#/
21E/M
GRID CIRCUIT
MODIFICATION PROCEDURE
STATION KREM

The purpose of this modification is to prevent arcing in the grid tuning capacitor of the 21E/M under dusty conditions. Such arcing has in some cases been erroneously interpreted as a grid-to-filament short in the final amplifier tube.

21E/M Cooling System Modification Procedure

### 21E/M ARC SUPPRESSION CIRCUIT

TOP VIEW - PAGRID BOX

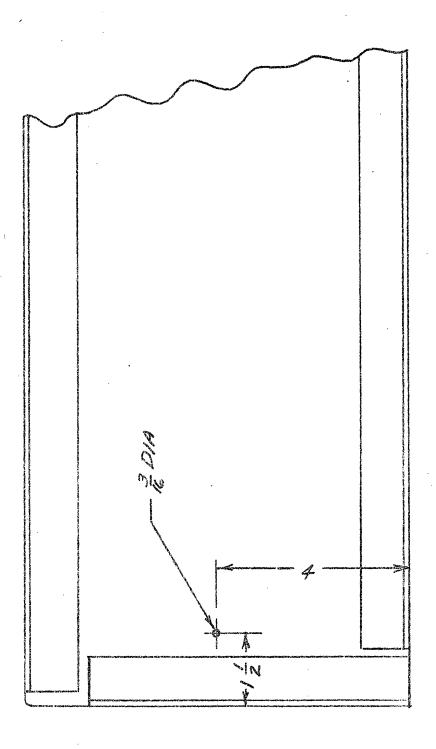
- 1. Locate and drill 3 holes in the top surface of the PA grid box as shown in Figure 1. (If the holes are drilled from underneath, measure inside the box, subtracting 1/8" from the 11-15/16 and 5-7/8" dimensions for metal thickness). CAUTION: Cover the blower opening while drilling to eatch the metal shavings).
  - 2. Mount capacitor C-372 (Item AA) on the undermeath surface, using 2

UPPER SUPPORT BRACKET ASSEMBLY DETAIL

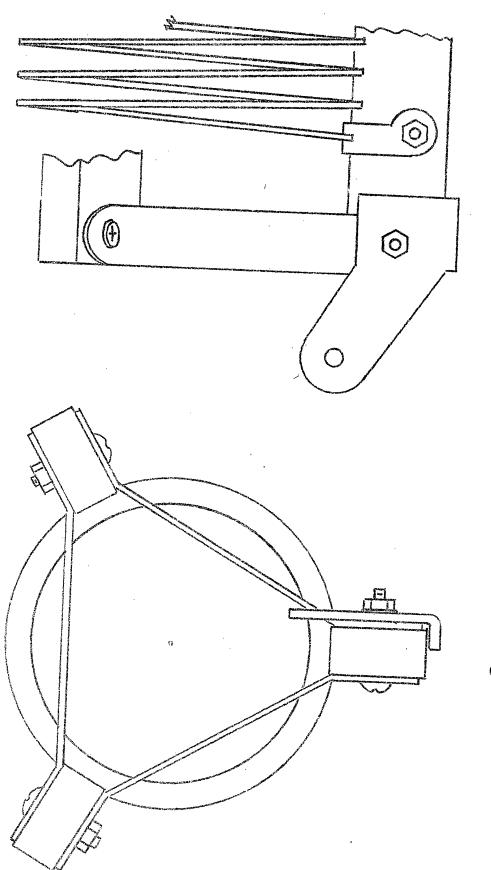
- 7. Connect another lug (item C) to the other end of R-348. Do not terminate at this time.
- 8. Refer to Figure 3, and assemble one clip (item B) to upper support bracket (item T) as shown, using 1 screw (item F), 1 lock washer (item L, and 1 nut (item E).

FIGURE 5

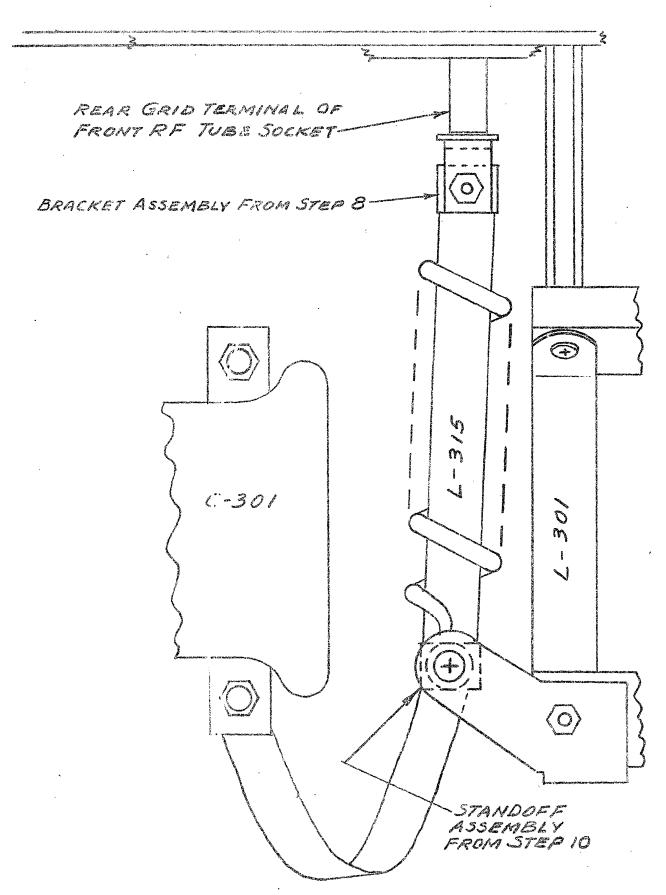
- 10. Refer to Figure 5. Assemble 1 clip (item B), and connecting strap (item V) as shown, using 1 screw (item G), 1 lock washer (item L) and 1 nut (item E). Assemble the metal washer (item N), 1 corprene washer (item AC) and ceramic standoff (item A) on the free end of the screw as shown.

FIGURE 6.

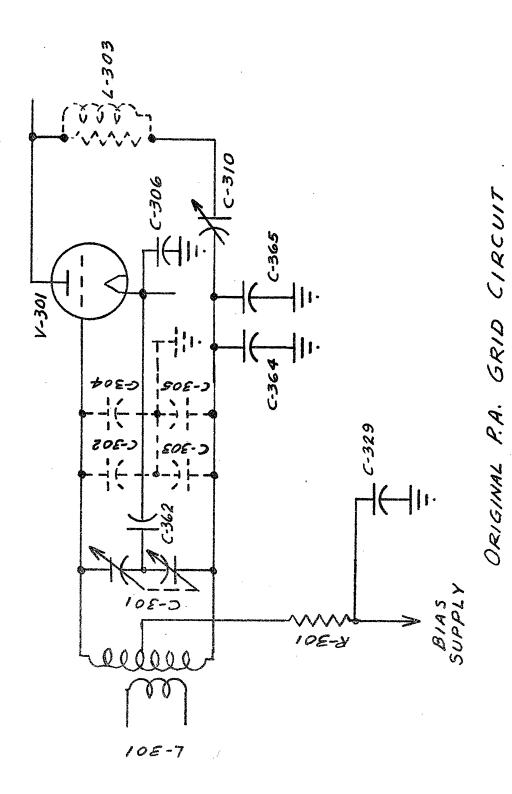
15. Refer to Figure 6. Mount the upper support bracket assembly (step 8 and Figure 3) in the rear hole of the rear grid terminal of the

- 16. Remount the grid coil. Mount the standoff assembly of step 10 on the support angle on L-301 as shown in Figure 6, using 1 screw (item F), 1 lock washer (item L) and 1 corprene washer (item AC). Connect the strap to the grid section (rear) of the stator of C-301.

FIGURE 7.

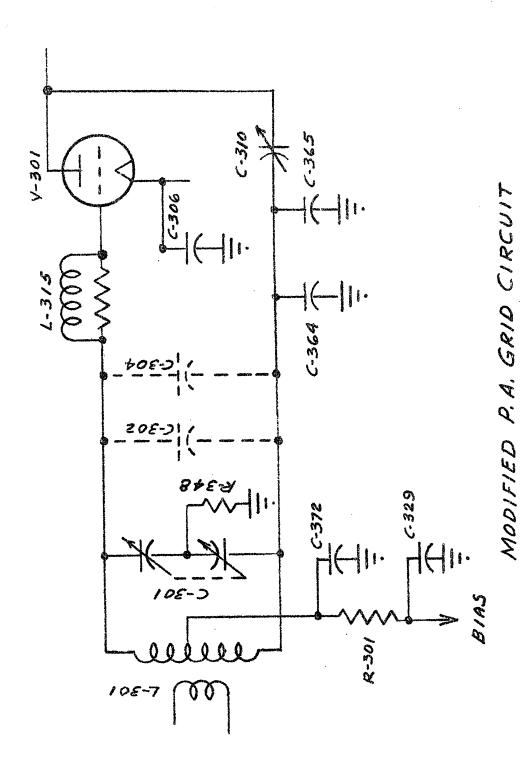
- 19. Connect the remaining terminal of C-372 (which was left floating in step h) to R-301. See Figure  $\theta_e$
- 20. Connect the remaining terminal of R-348 (which was left floating in step 7) to the rotor of C-301 by fastening its lug under the screw holding C-301 to its mounting plate.

FIGURE 1.

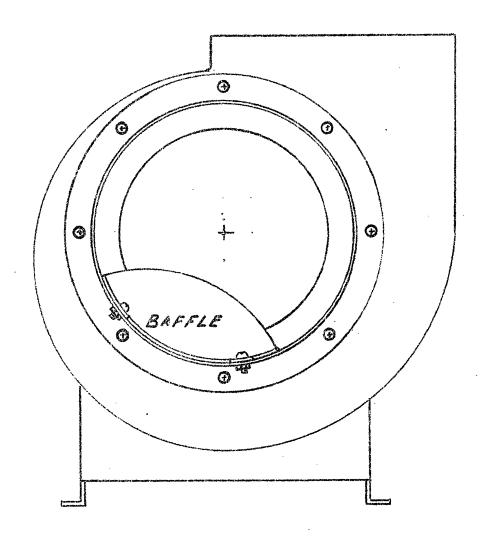
- 1. Remove the rear filter panel from the PA bay. This panel may be discarded, or stripped and kept as a spare for the back panel of the driver bay.
- 2. If equipment is operating on 50 cycle power, check the blower intake. If a "U" shaped strap is mounted across the intake, remove and discard it. Omit steps 3 through 6.
- 3. On 60 cycle equipment, remove and discard the strap connected across the blower intake. Dismount the blower intake ring.
- 4. Locate and drill two holes in the intake ring for the baffle (item H) as shown in Figure 1. Make sure the holes are accurately centered on a centerline between two of the intake ring mounting holes.
- 5. Mount the baffle using 2 screws (item D), 2 lock washers (item E) and 2 nuts (item C).
- 6. Remount the intake ring-baffle assembly on the blower in the relative position shown in Figure 2.

DRILLING TEMPLATE FOR RIBA, R347
FIGURE

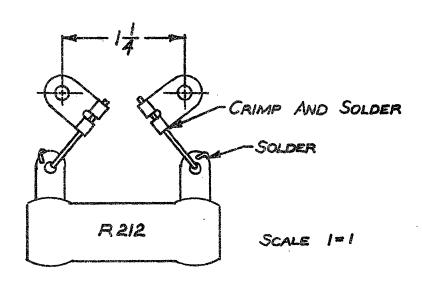
- 5. Remove the air filter panel from the rear of the driver bay. Drill 2 holes (using drilling template, figure 1, enclosed) for R-184 in the flange of the cabinet corner post near control circuit breaker S-106.

- 10. Remove the front lower insert panel from the PA bay. Drill 2 holes (using drilling template, figure 1) for R-347, above and to the left of terminal board E-302.

INSIDE VIEW OF TOP OF DRIVER TANK BOX

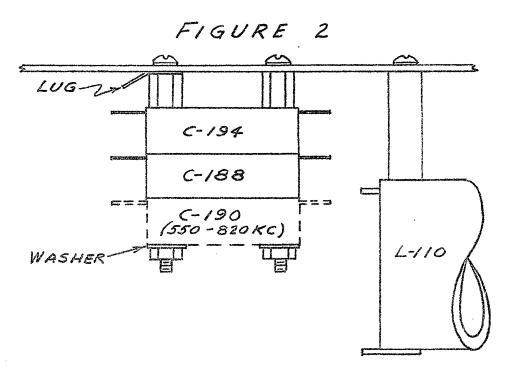
- 1. Remove the tank box cover in the driver bay, and locate and drill mounting holes for C188 and C194, and rubber grommet (item C) as shown on Fig. 1. Insert rubber grommet (item C) in the 5/16 D hole.

MOUNTING DETAIL FOR CAPACITORS C-188, C-190, C-194

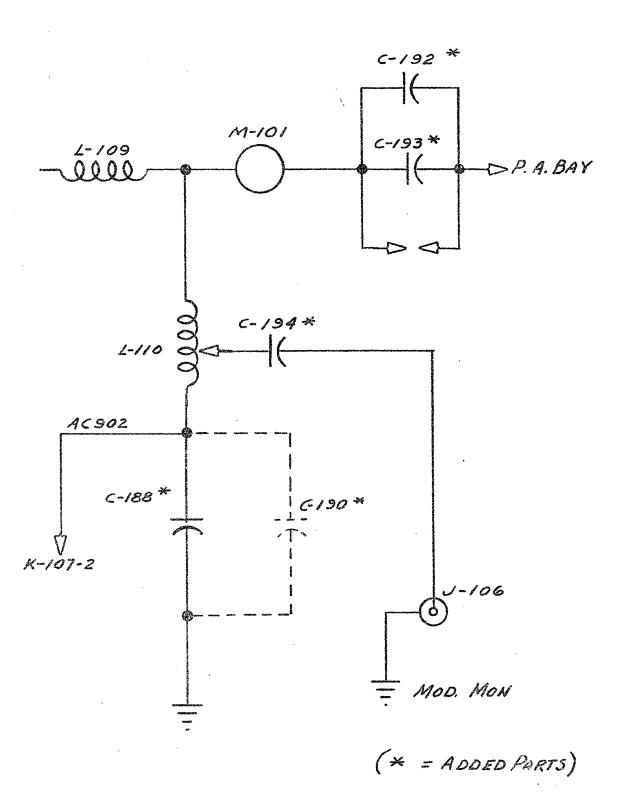
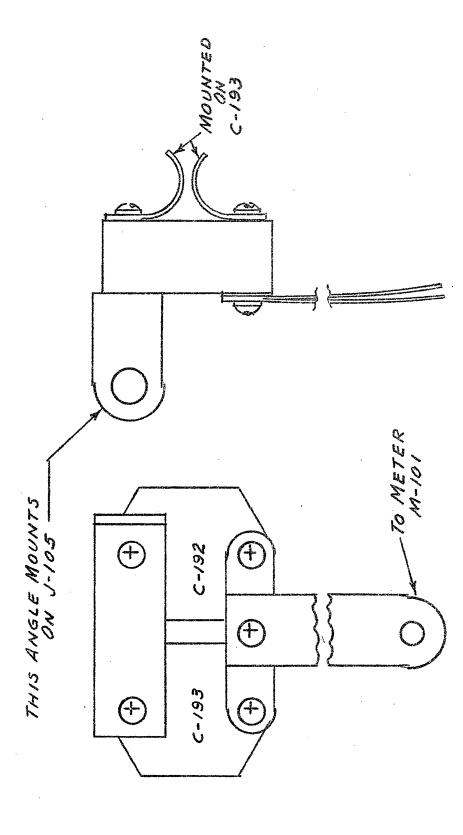
- 2. Mount capacitors Cl94 (item AU), Cl88 and Cl90 if used (item AV) as shown in Figure 2, using two screws (item S), one soldering lug (item F), two spacing posts (item AG), two flat washers (item H) and two nuts (itemK). If Cl90 is not used, the mounting screws may be clipped off short or left long, as desired.

FIGURE 4

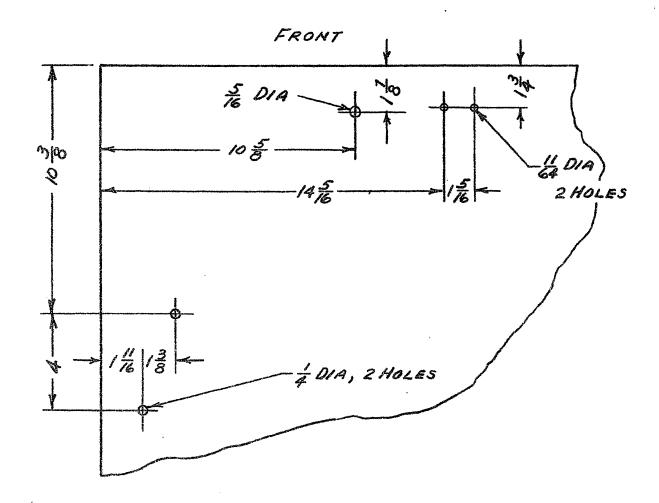
- to the ground lug, again using No. 16 bus. Replace the tank box cover.
- 5. Mount the two arc gap arms (item AS) on capacitor C193, using two screws (item Q) and two lock washers (item U). Refer to Figure 4, and mount C192 and C193 (item AW) on the capacitor mounting angle (item AQ) and the capacitor mounting strap (item AR) using four screws (item Q), and four lock washers (item U). Mount two meter capacitor straps (item AP), using one screw (item Q), one lock washer (item U), and one nut (item K). The appendix should now look like Fig. 4.
- 6. Remove the strap connecting M101 to J105, and replace with the C192-C193 assembly of Step 5.
- 7. Remove the PA tank box cover, and locate and drill mounting holes for C367, C368, C369 and rubber grommet (item D) as shown on Fig. 5.

ORIGINAL MODULATION TRANSFORMER CIRCUIT
FIGURE 1.

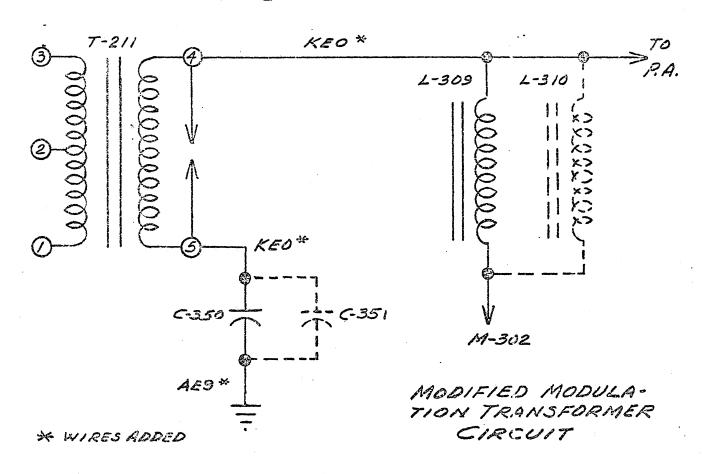
- 1. Remove the back panels from the PA and rectifier bays:
- . 2. Refer to Fig. 1. Remove and discard the AE9 wire connecting terminal 5 of T-211 to the ground stud in the rectifier bay.
- 3. Remove and discard the KEO wire connecting terminal 4 of T-211 to C-350(and C-351, in a 21M).
  - 4. Remove and discard the KEO wire connecting L-309 to C-350 (and C-351).
- 5. Refer to Fig. 2. Connect L=309 to terminal h of T-211, using KEO wire (item D) and 2 solder lugs (item B).
- 6. Connect terminal 5 of T-211 to C-350 (and C-351) using KEO wire (item D) and 2 solder lugs (item B).
- 7. Connect the remaining terminal of C-350 (and C-351) to ground, using AE9 wire (item E) and 2 solder lugs (item C). On the 21E, this ground point can be the ground stud on the PA bay relay panel (E-306). On the 21M, either this same stud, or the grounded terminals of C-354 thru
